Detailed Site Plan Alternative Compliance Smith Lakes Estates

DET-2024-015
ACL-2025-0007

SUBJECT: Detailed Site Plan DET-2024-015
Alternative Compliance ACL-2025-0007
Type 2 Tree Conservation Plan TCP2-2025-0066
Smith Lake Estates

Figure 6: Staff recommended active recreation area and stormwater Management area for open space set-aside.

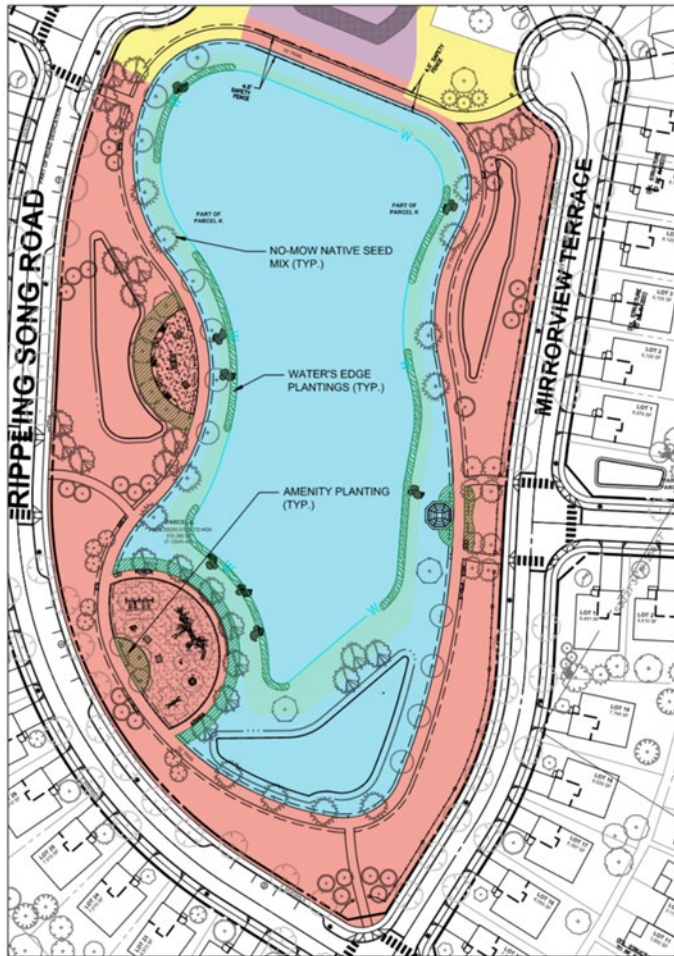
A condition requires the applicant to revise the Open Space Set-Aside exhibit to match the site plan. The area between the trail/playground and the pond should not be counted as active recreation. The current plan shows 34.7 percent active recreation; reducing this area will still meet the 15 percent minimum. The applicant must (1) Limit active recreation to the area between the trail/playground and adjacent public

roads (2) Expand SWM within the trail/playground area (only 75 percent counts toward open space set-aside).
